ADDENDUM NO. 1 TO BID FORMS

**CORONA-NORCO UNIFIED SCHOOL DISTRICT
PURCHASING DEPARTMENT
Bid No. 2023/24-204**

CORONA FUNDAMENTAL INTERMEDIATE SCHOOL MPR MODERNIZATION

CLASSROOM RM 20 - WEST 5
SCALE: 1/4" = 1'-0"

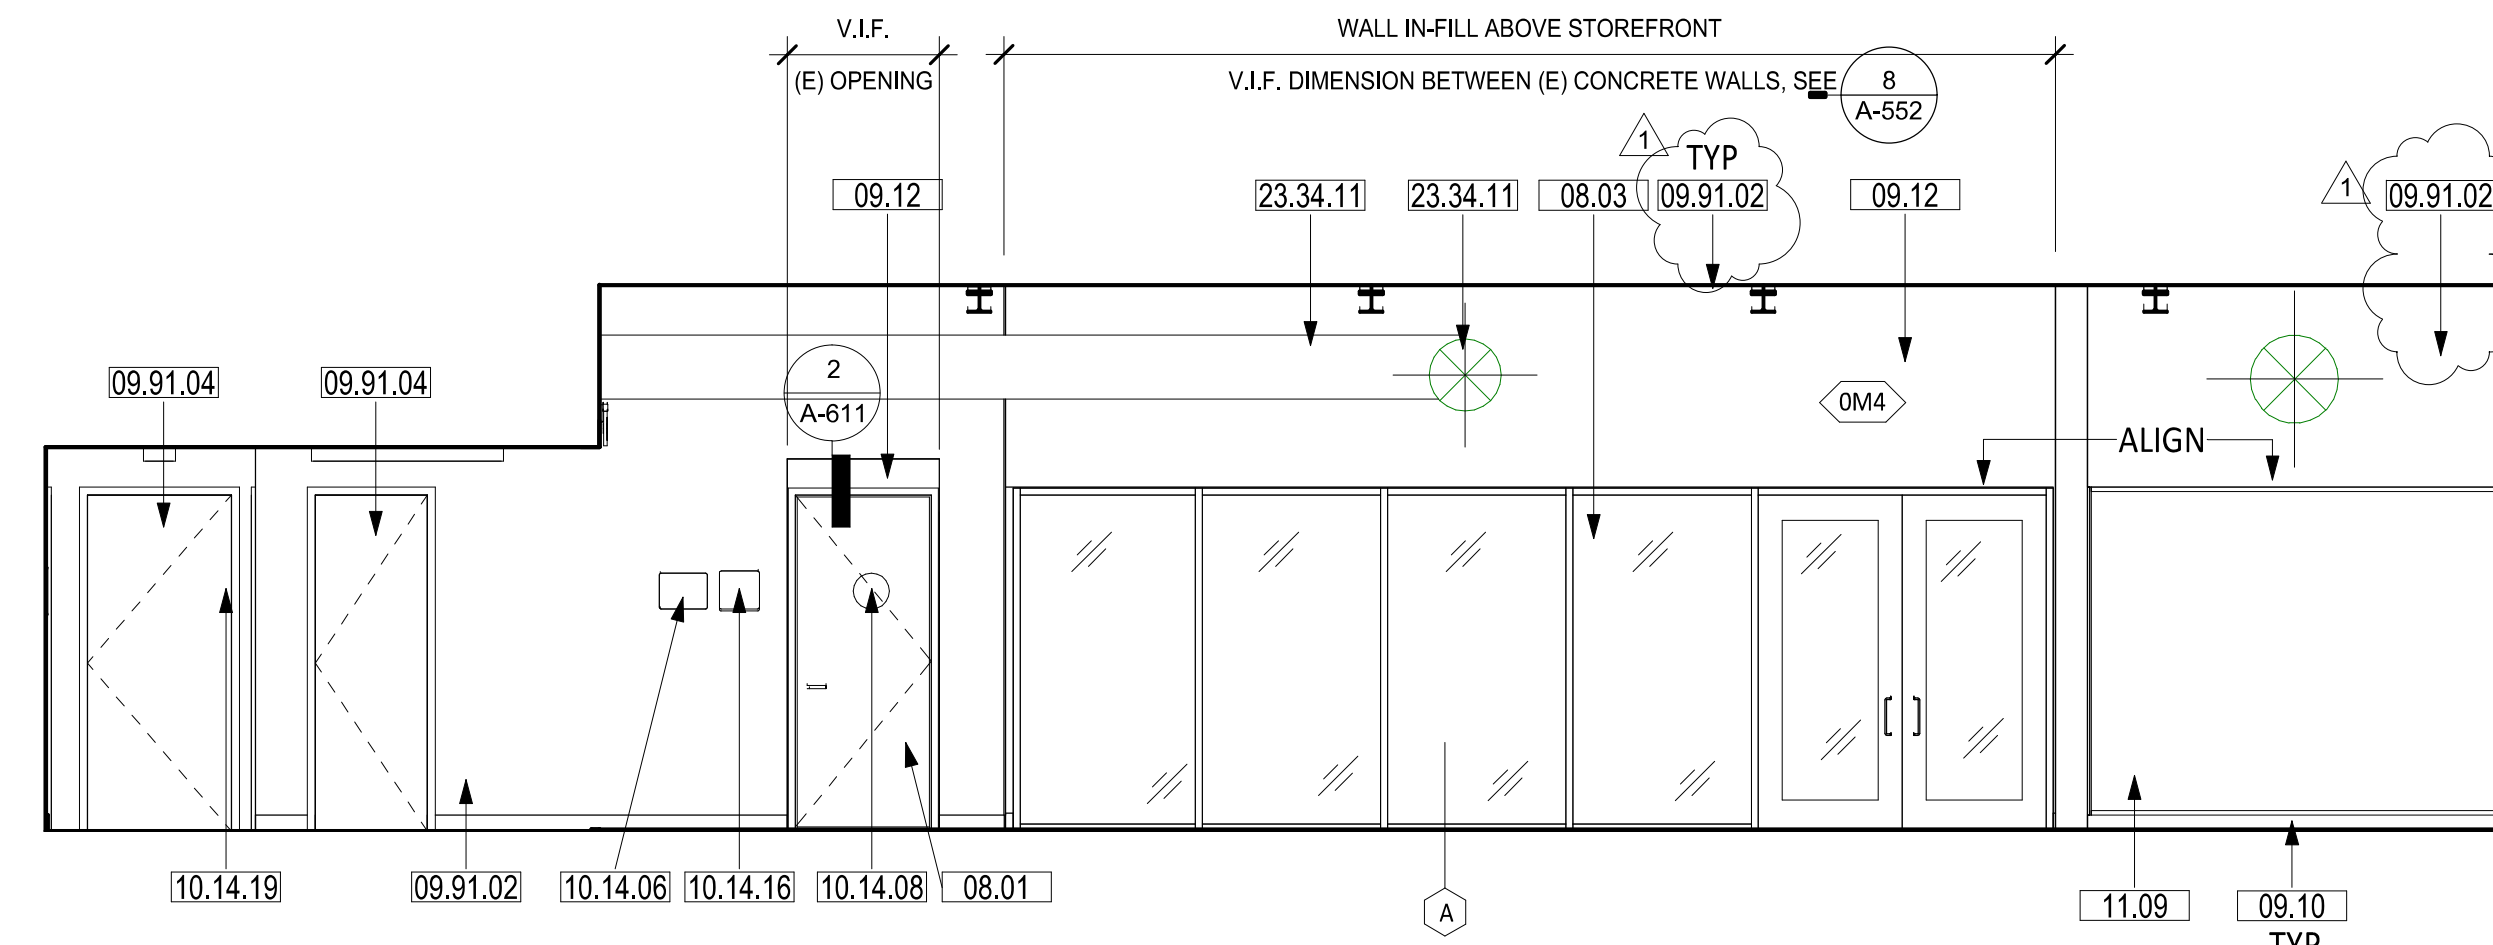
Item No. 1.10
Sheet A-431 - CLASSROOM ROOM 20 - ENLARGED PLAN & INT ELEVATIONS

- Floor mat added and keynoted at Door E20 in Classroom 20
- Keynote 12.70 added for floor mat

SHEET NO.:
A-441

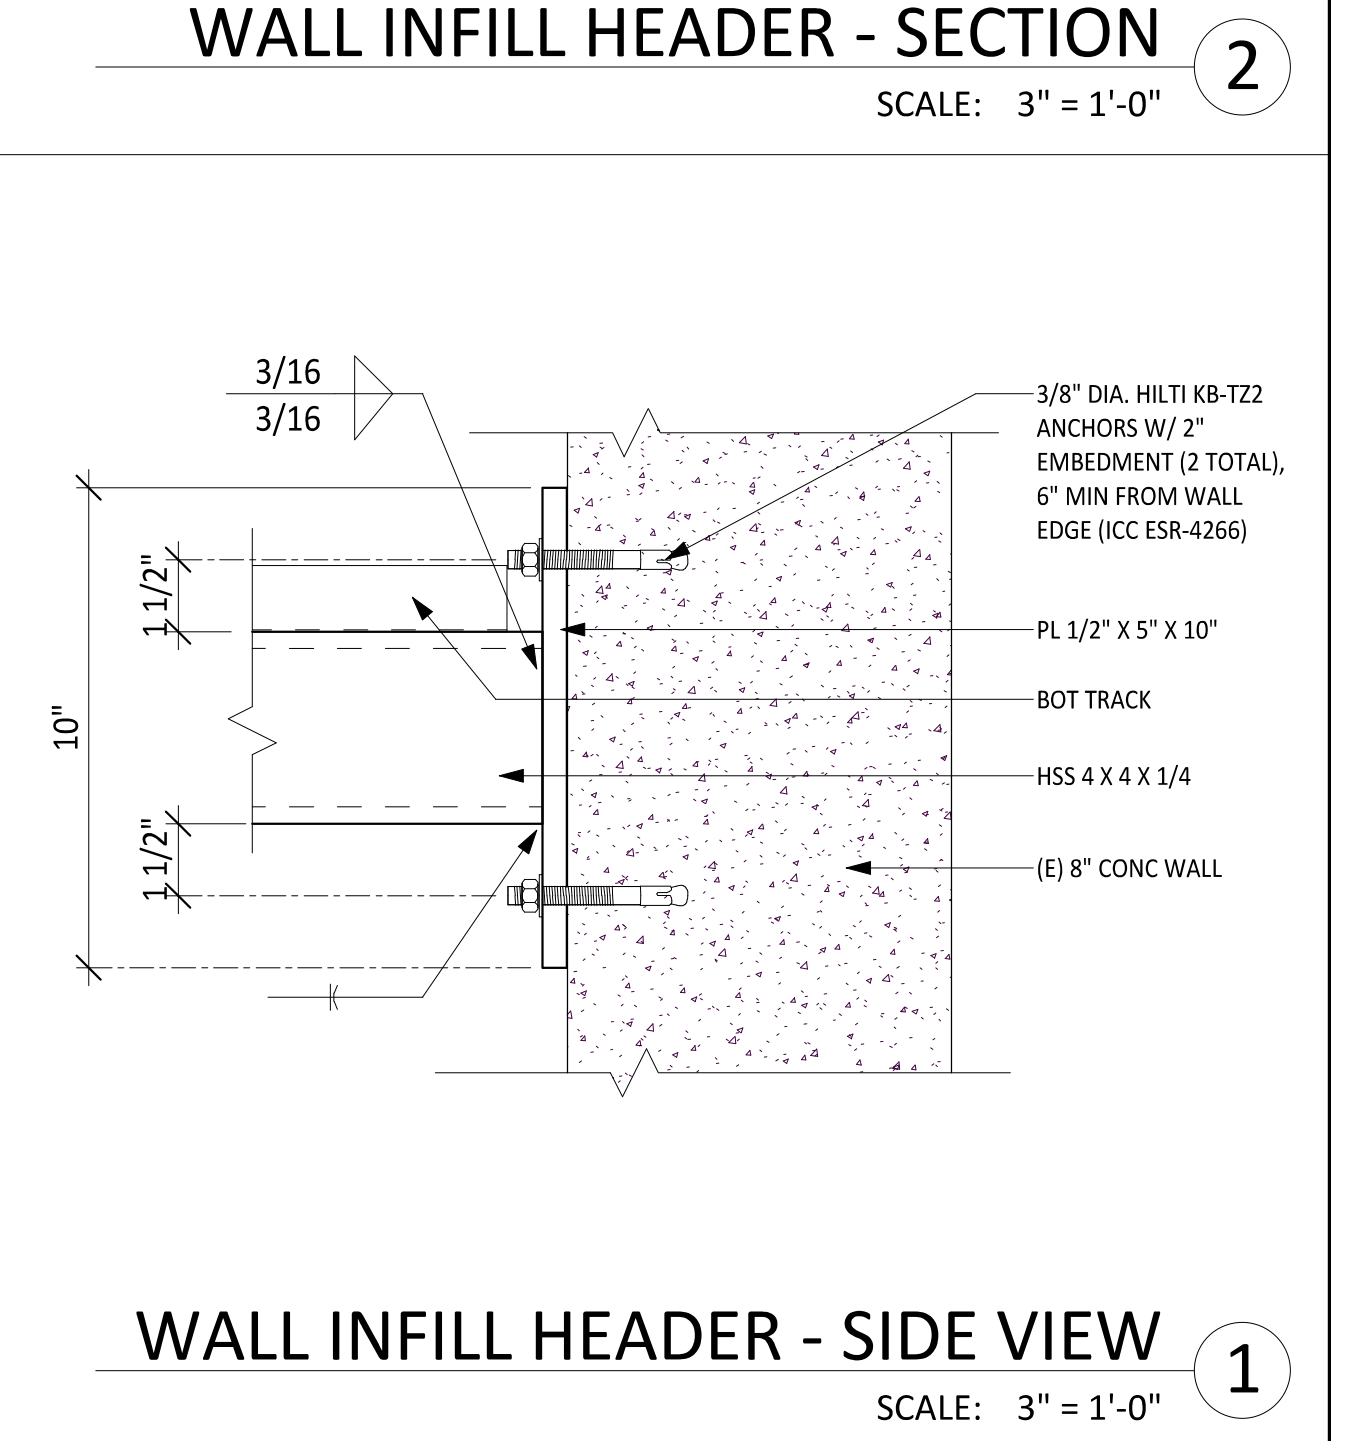
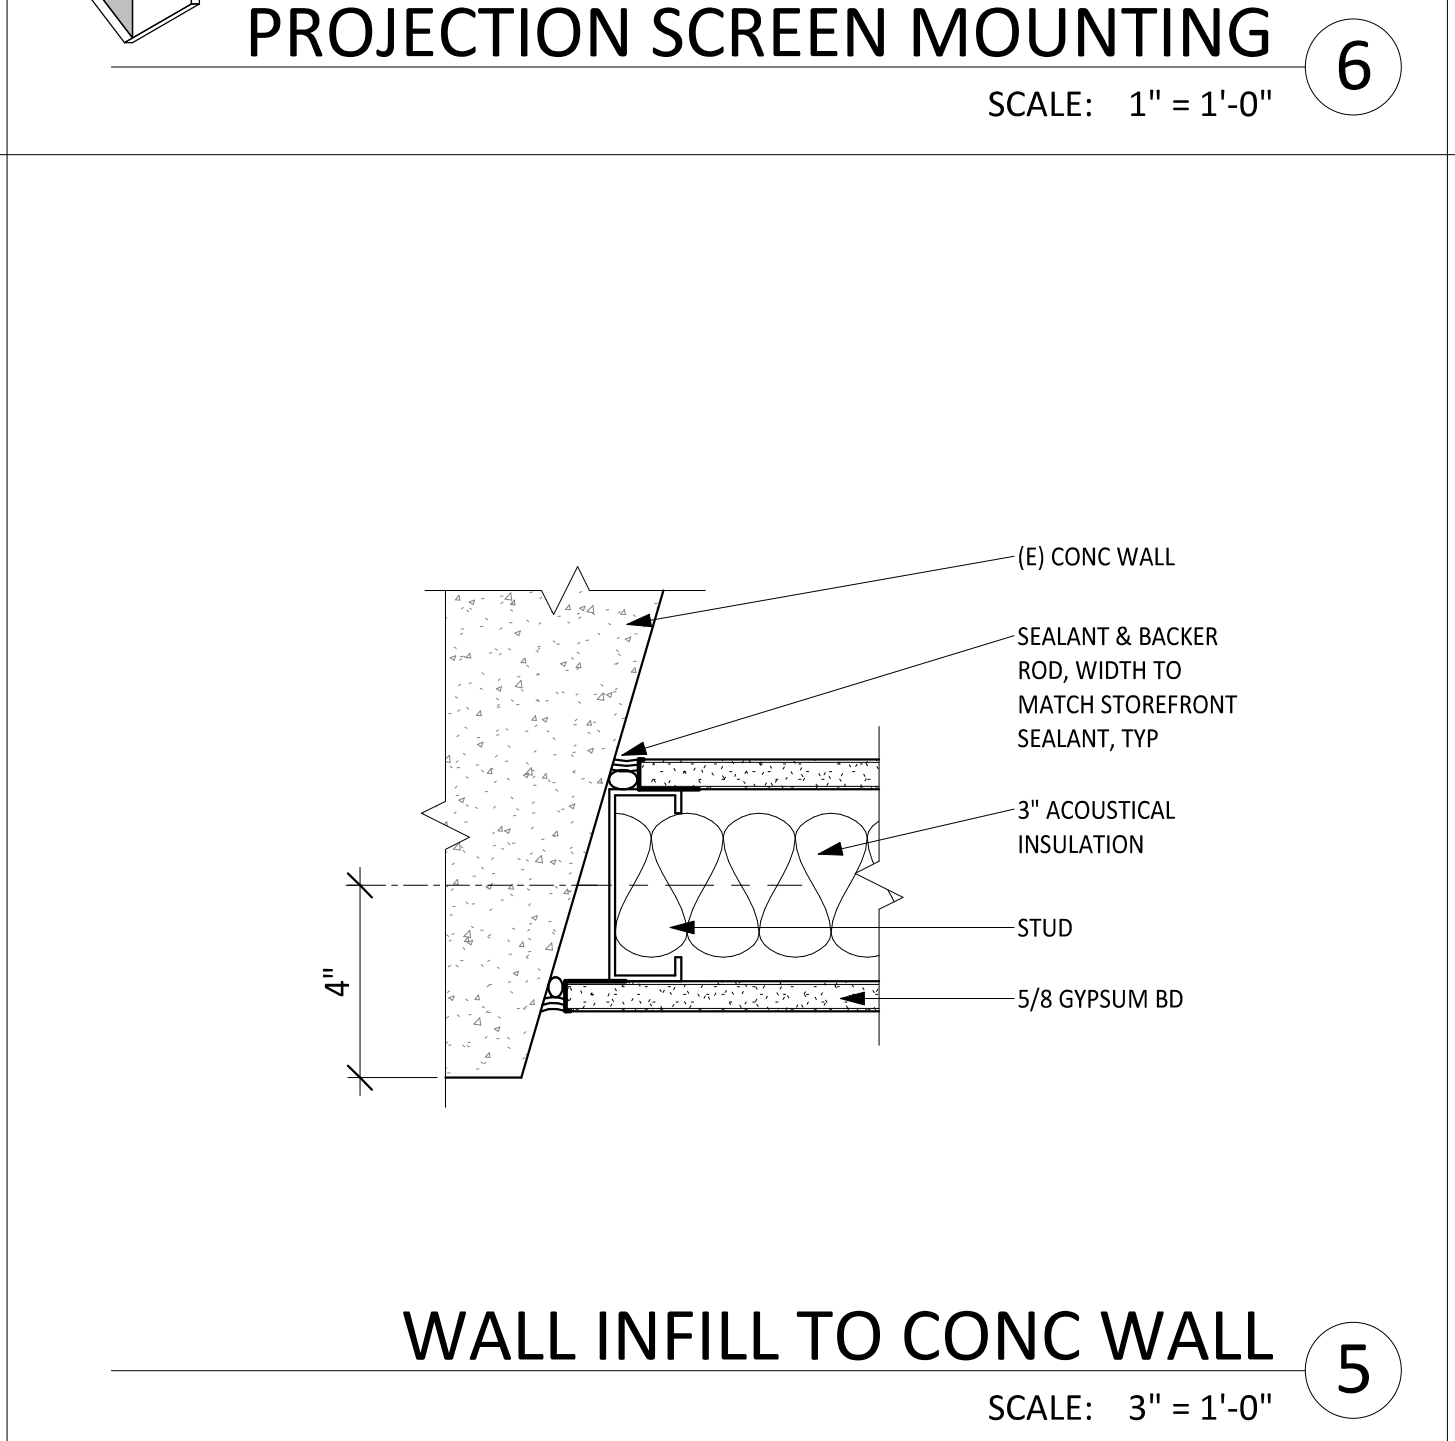
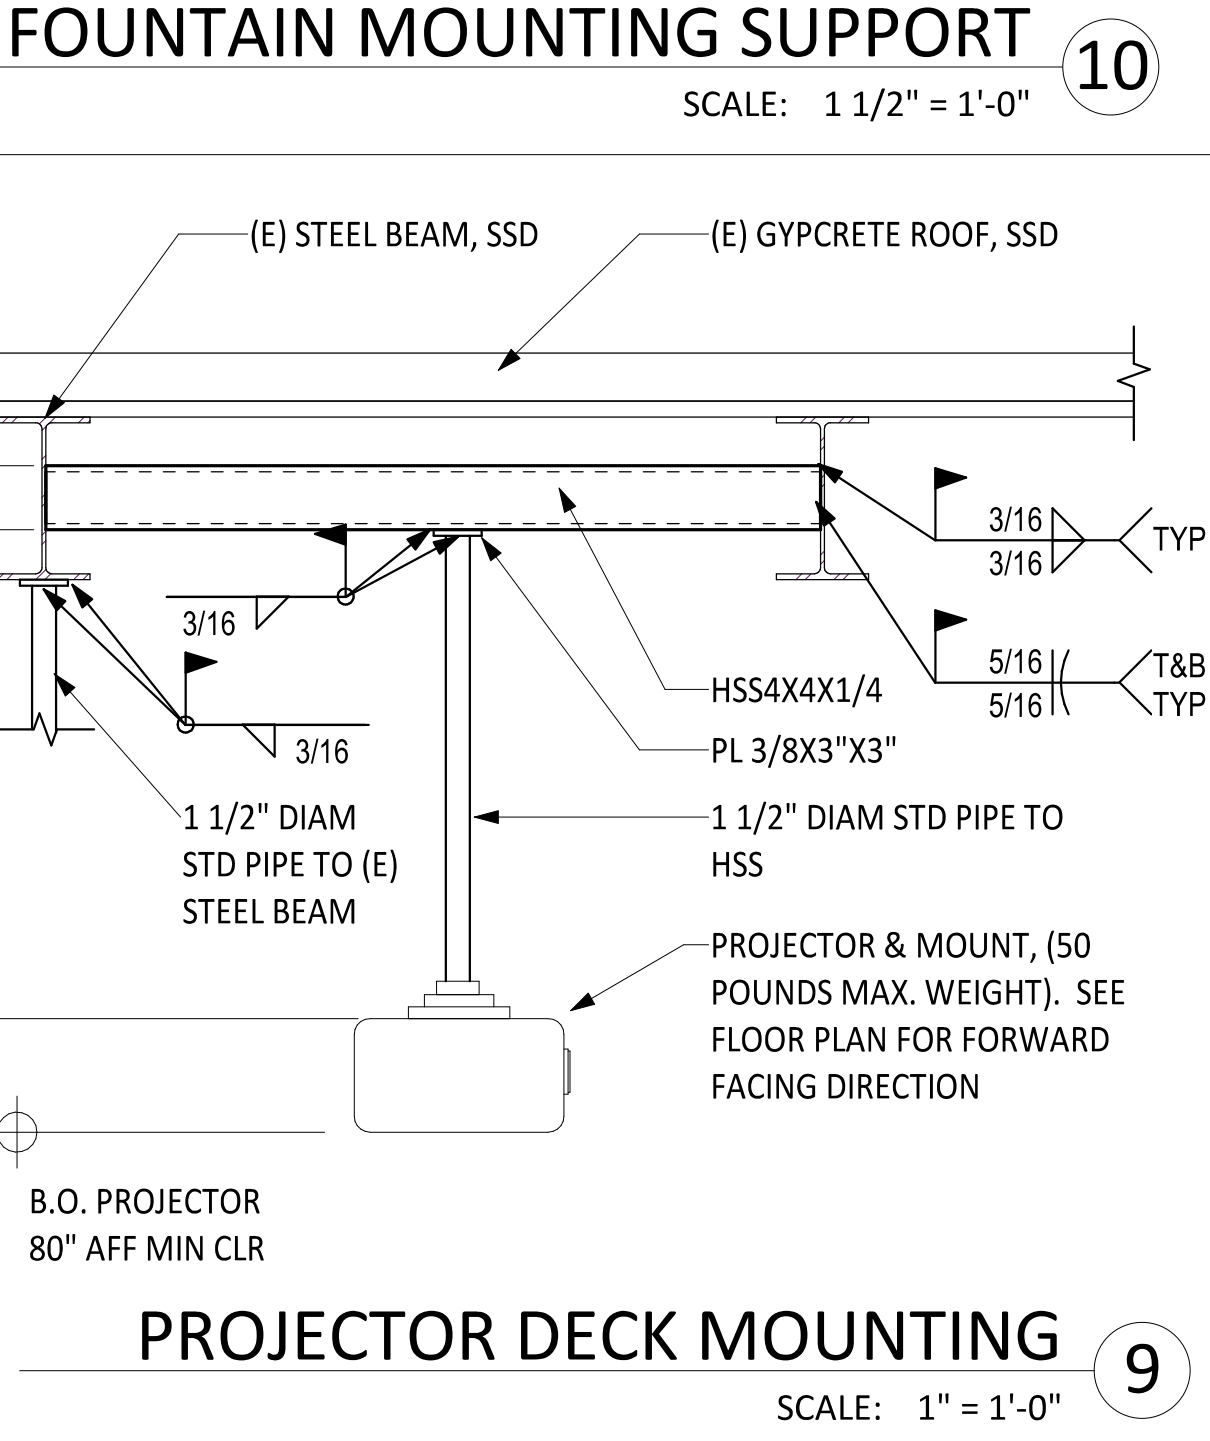
Item No. 1.11
Sheet A-441 - INTERIOR ELEVATIONS

- 1/A-441, 2/A-441, and 3/A-441 revised to reflect Girls' Toilet Room 9 layout

SHEET NO.: **A-641**

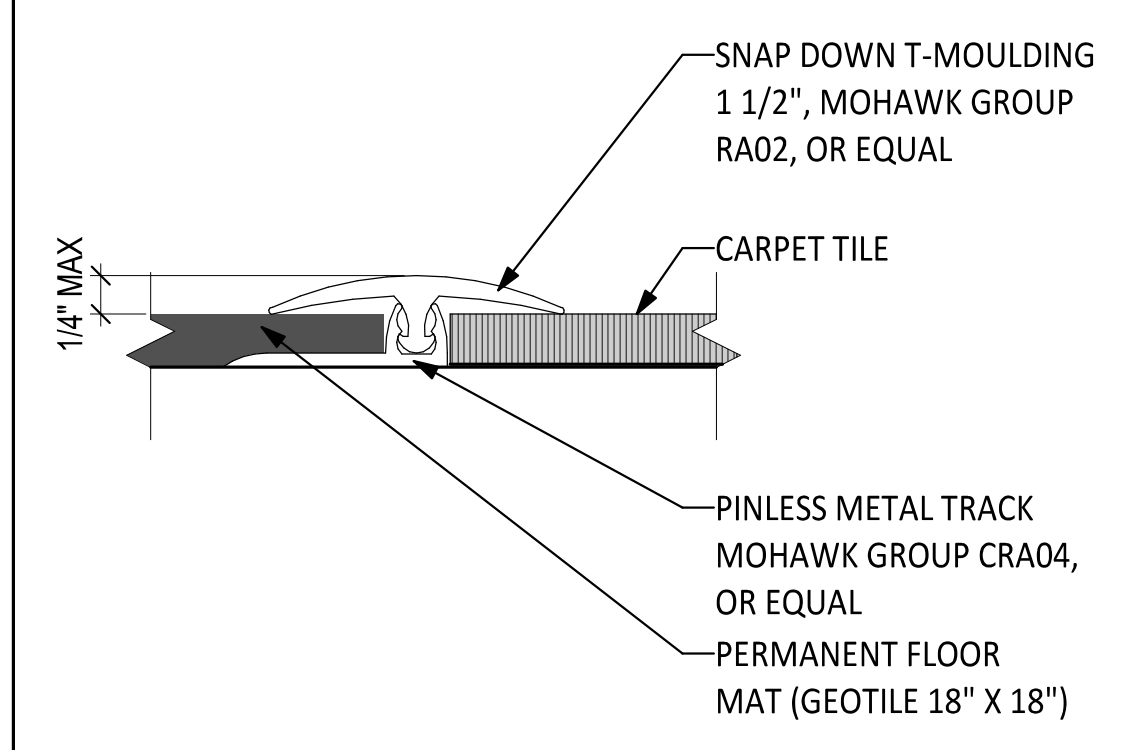
Item No. 1.14
Sheet A-641 - FINISH SCHEDULE & TYPICAL DETAILS

- Note added regarding floor mat in Classroom 20
